MINI THERMOSTAT REDESIGN TO OVERCOME OVERHEATING ISSUES

Issue Date: 23/09/19 Issue Number: COTB0027B

APPLICATION : Mini R55, R56, R57, R58, R59, R60, R61

Product Information

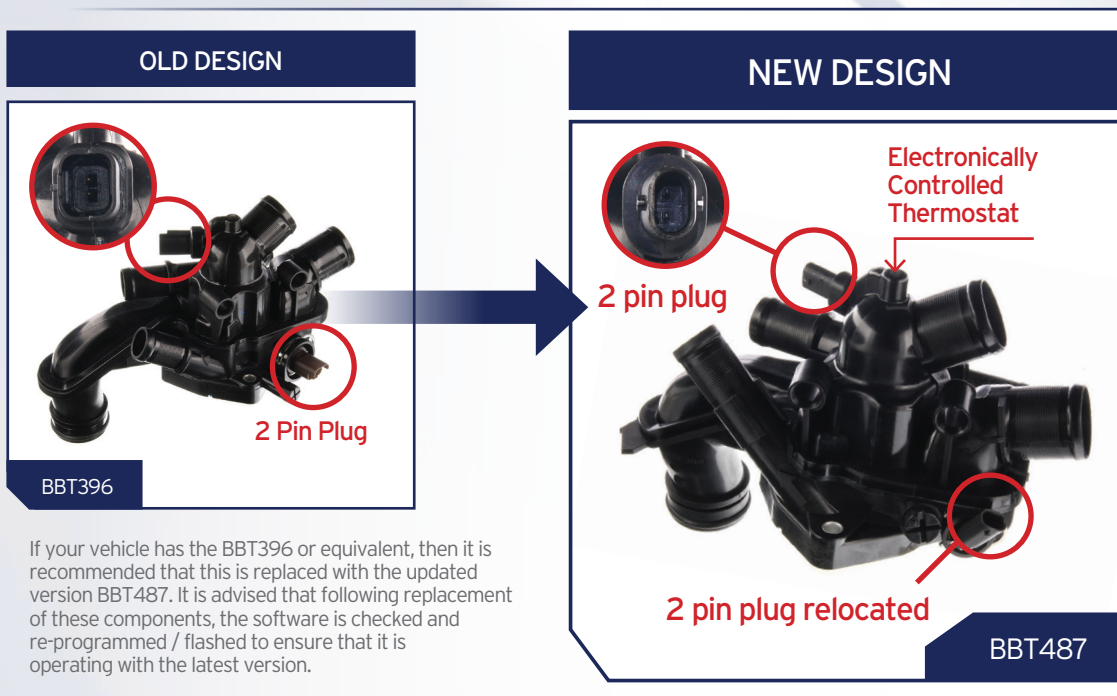
Due to an increase in overheating issues & symptoms such as an erratic temperature gauge, erratic running, radiator fan run-on, or poor heater function in the above vehicles, the O.E.M. have modified the design of the Thermostat housing. Following the O.E. specification, we have replaced the old design BBT396 with the new latest design BBT487. The latest design benefits from an electronically controlled thermostat, a reinforced structure, and a new configuration of sensors.

We have highlighted the key differences below so that you are clear that the latest part; although visually different to what may be on the vehicle, is in fact the correct product.

The modified version has had the lower 2 Pin connector relocated, therefore, a new cable may also be required to carry out the modification.

New Cable: BTS3092 - Thermostat Wiring Harness
